# HAZOP Report

## Project Marlin: EGP Reversal

GPA Document No: 20617-REP-020  
Client Document No: GAS-599-RP-HZ-003

The following report summarises the findings of a Hazard and Operability Study, HAZOP, held on Microsoft Teams on the following dates: 5<sup>th</sup>, 16<sup>th</sup> – 18<sup>th</sup> November 2020. The HAZOP dealt specifically with design facilitating the EGP flow reversal.

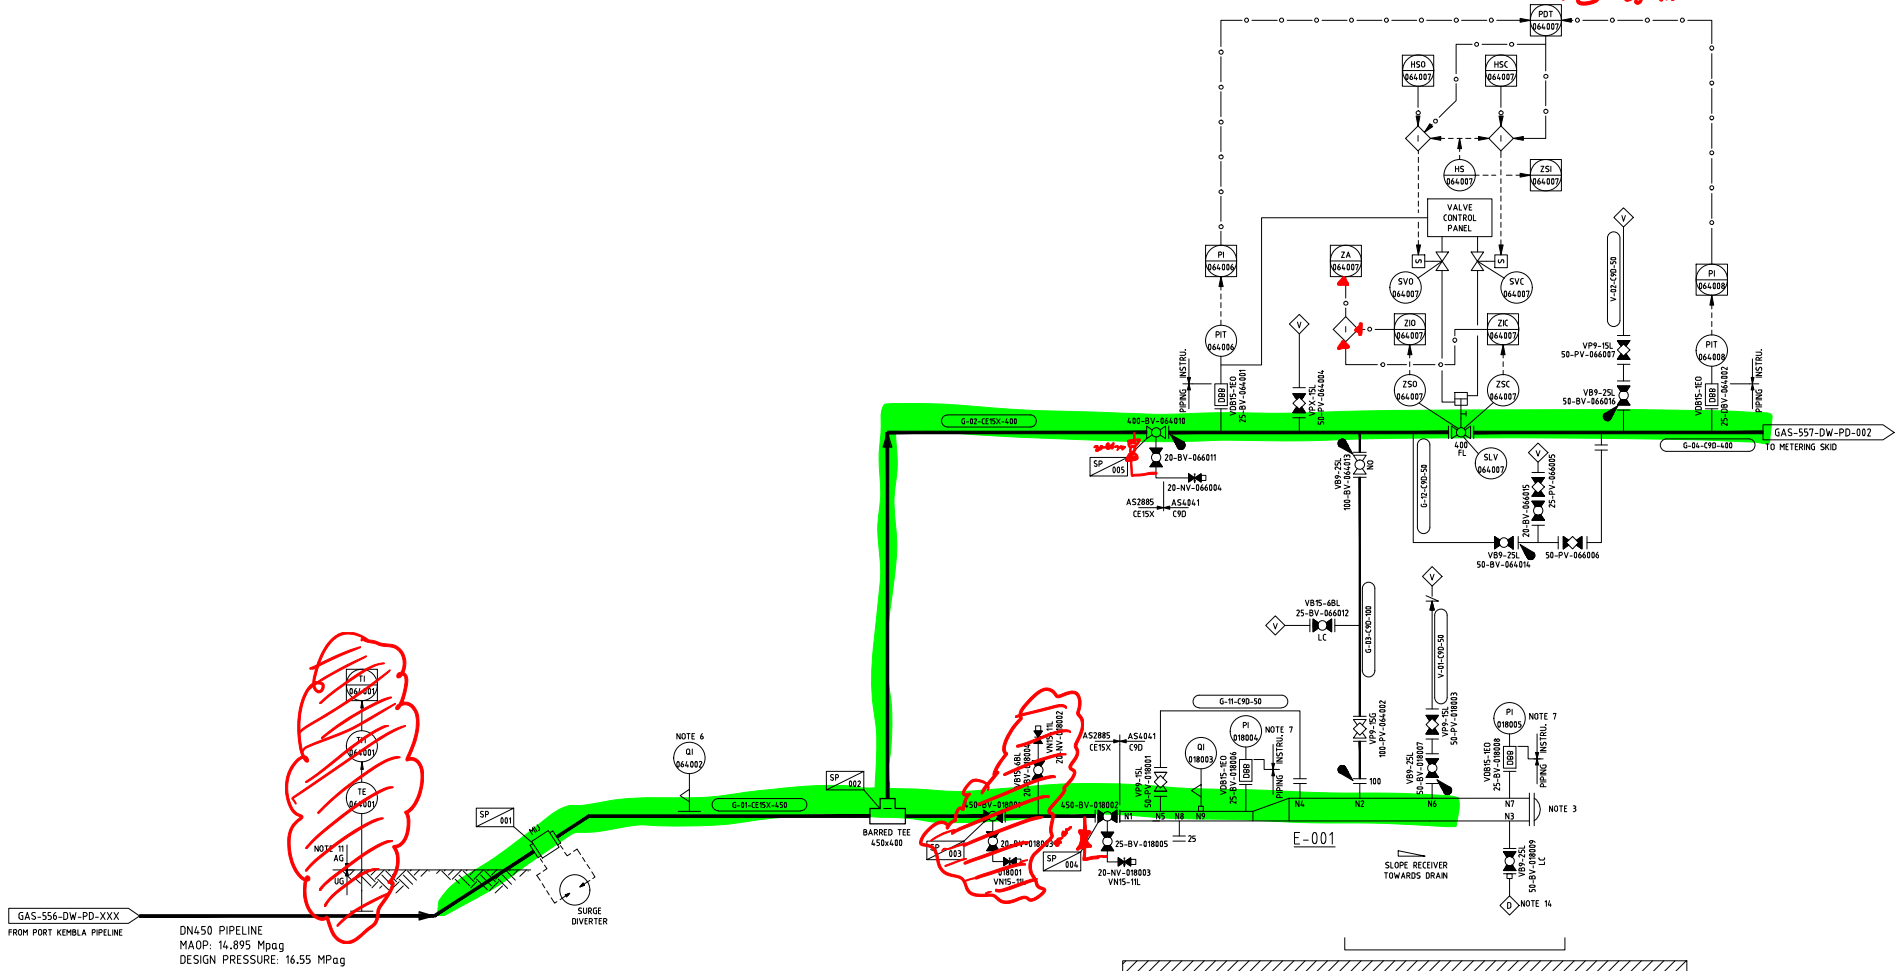
4.1	HIGH FLOW	Failure of PV 062005 or PV062007	Over pressure. Noise. Operators attend site once a month for site inspections, failure would go undetected. PSV vents to atmosphere.	PSV 062008	Change PI to PIT with high and low pressure alarm (PI62008)	1	SH

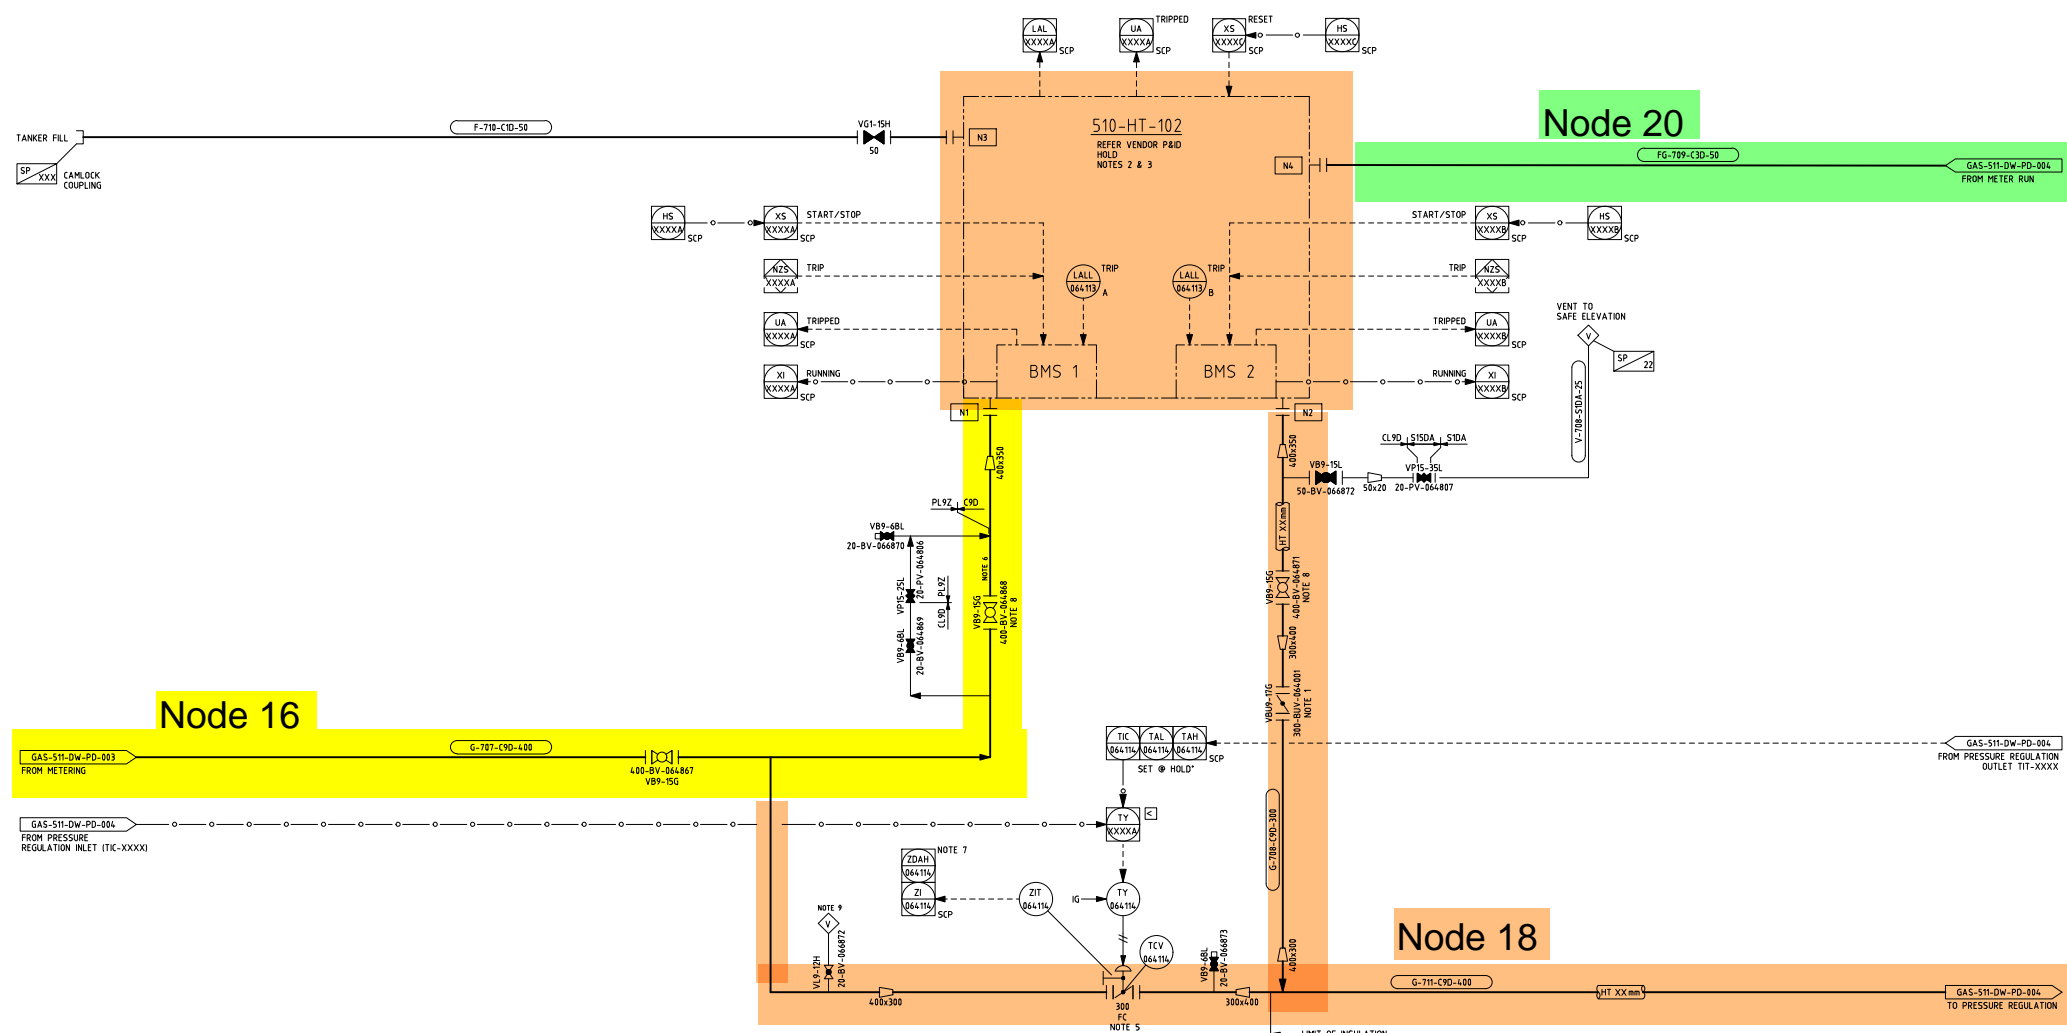
16.2	HIGH LEVEL	Liquid slug  Entrained oil from upstream gas compressors at Orbost and/or ESSO  Entrained hydrocarbon liquids  Inadequate operation of manual liquid draining of Filter 510-F-103	Liquid carry-over, resulting in off-spec gas	High level alarm LSH-011107/8 on Filter 510-F-103  HH level shutdown on LSHH-011107/8 on Filter 510-F-103  Inlet gas supplied per AS4564 gas specification.	P&ID and datasheet to show that Filter 510-F-103 liquids collection boot is separated into two compartments. P&IDs currently shows this as one compartment which would allow gas to bypass the filter element.  Add transmitter to LG-011107/8	1  1	PB  AZ

16.7	HIGH PRESSURE	Inadvertent opening of UV-6470	High pressure from compressor discharge header  Very high flow through Filter 510-F-103, leading to filter element damage	Refer High Flow  The pressure rating of the piping system and equipment exceeds the upstream pressure source.	Correct the PSV set-point shown on the P&ID for Filter 510-F-103.	1	SH

16.16	PLANT ITEM OPERABILITY	Closure on filter, type shown on P&ID is the preferred option  Pigs – direction of pigging is unknown	Need to be able to receive a pig if flowing from north to south		Pigs – confirm the planned direction of pigging and review the configuration of the pipework to ensure that a pig can be received at the Longford Compressor Station Pig Barrel (location of kicker and equalisation line)	2	DY

16.17	PLANT ITEM MAINTAINABILITY	Isolation of filter or strainer for maintenance  Meter – single series with no double head for proving	No way to re-pressurise after isolation for maintenance. Large ball valve required to open to re-pressurise isolated strainer/filter, leading to damage to large ball valve.  After 10 years difficult to prove the calibration (Esso sometimes query this) No immediate concerns		Strainer - install a pressurisation line around valve 400-BV-064844.  Filter - install a pressurisation line around filter isolation valve 400-BV-064844 including an RO to limit the pressurisation rate of the filter and avoid damage to the filter elements.	1	PB

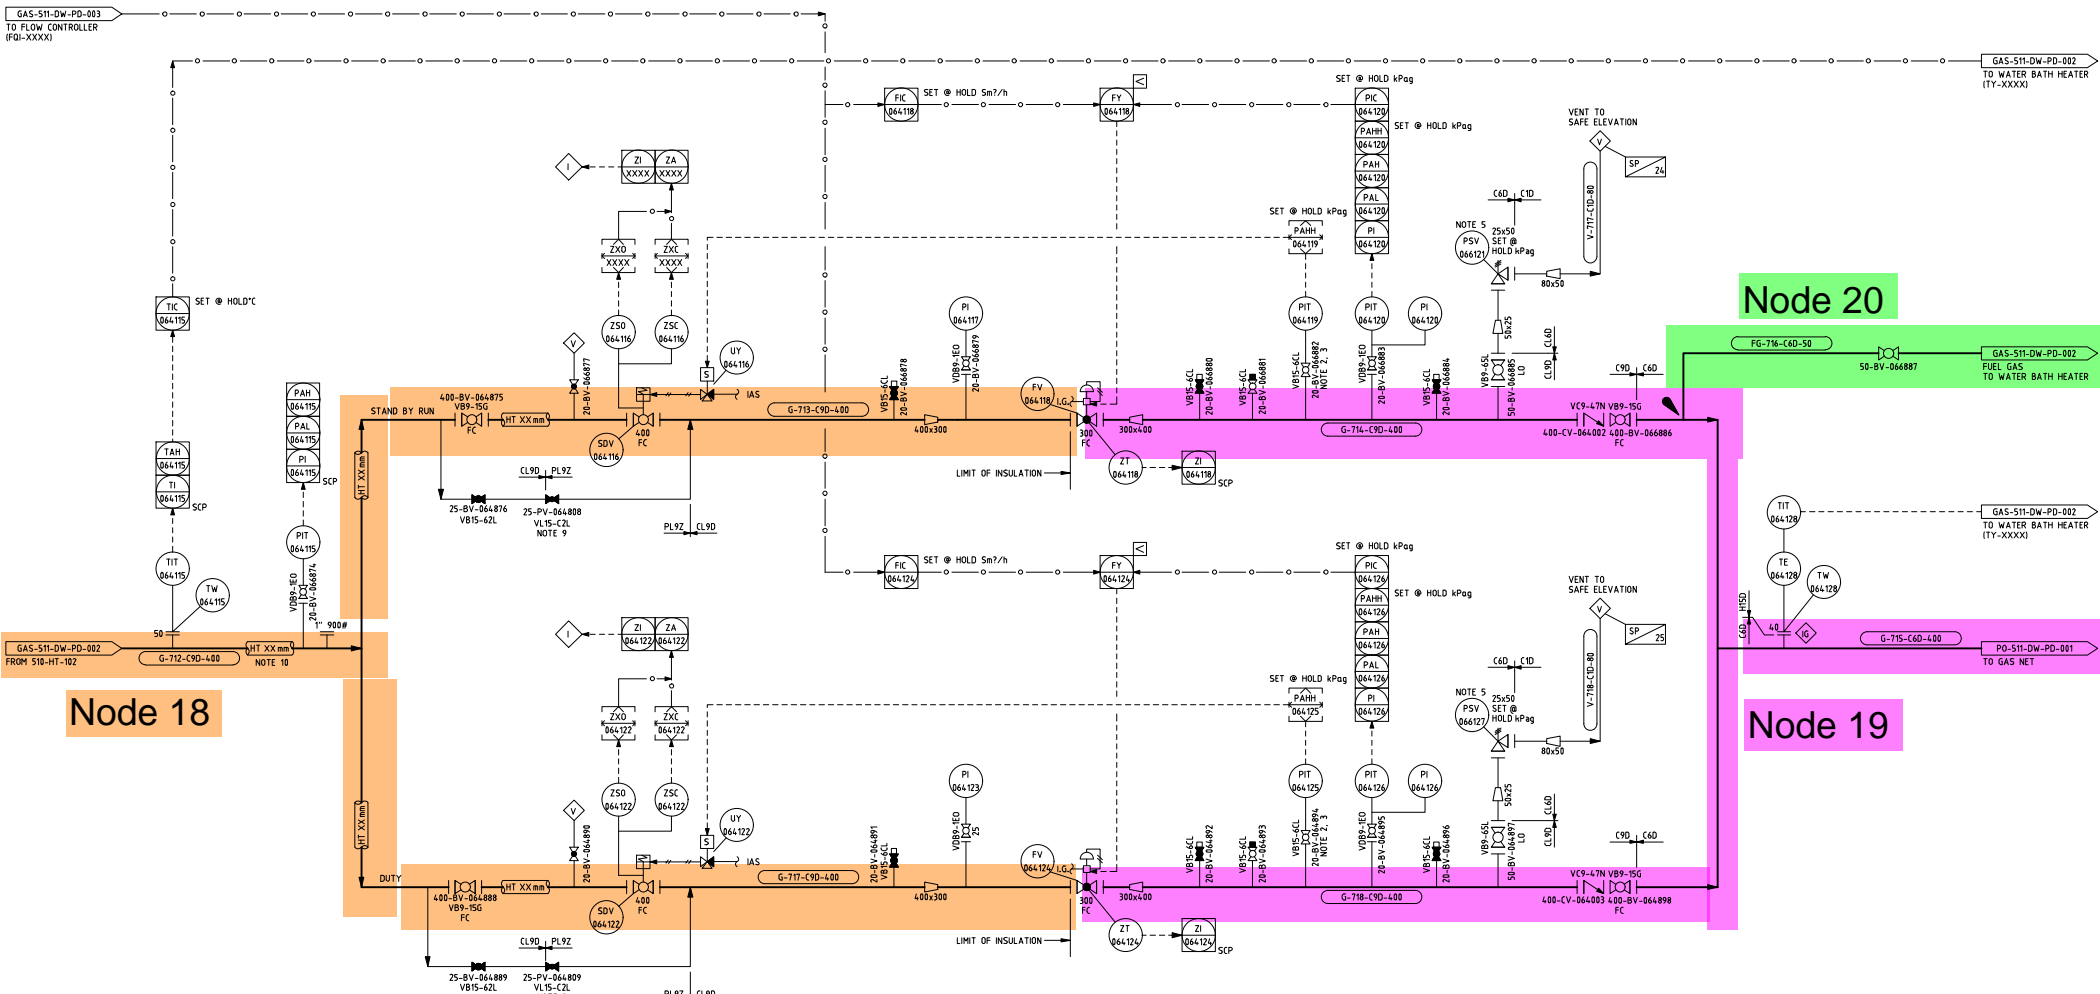
18.10	LOW TEMPERATURE	TCV open too far	Low temp trip downstream AEMO may call with a warning	Discrepancy alarm on TCV Low temp on alarm at regulator outlet (64115)	Add low temperature trip to TIT-64128.	1	AZ

18.17	PLANT ITEM OPERABILITY	Insufficient isolation to maintain TCV-64114 with heater 510-HT-102 online.	Maintenance cannot be completed without depressuring the heater 510-HT-102 and using isolations further upstream/downstream.	Heater can be used with some limitations if TCV-64114 is out of service VicHub 1 heater 510-HT-101 available Valve body/internals not expected to require repair Valve actuator and instrumentation can be maintained with the valve remaining in service. Note – TCV is butterfly type and may be wafer style  Can be repaired / replaced during a shutdown	No action required

18.18	PLANT ITEM OPERABILITY	No bypass arrangement for bundle inspection. Intention is to isolate the run. If VH2 WBH is out and VH1 WBH fails we will lose flow or capacity		Philosophy for maintenance is to isolate whole run to work on the heater. There is 2 tube bundles runs (burners) with redundancy during normal operating conditions.	Removable spool required to get the bundle out (add note to P&ID)	1	SH

18.23	EARTHING	Nil							
18.24	ISOLATION	Bleed is not available between the ball and the plug on the bypass line around BV-64875/64888	Not able to achieve DB&B		Add bleed point between ball and plug valve on pressurisation line around inlet isolation valves BV-64875/64888.  Change pressurisation line configuration to 2 ball valves and an orifice (with a bleed)	1  1	PB  PB
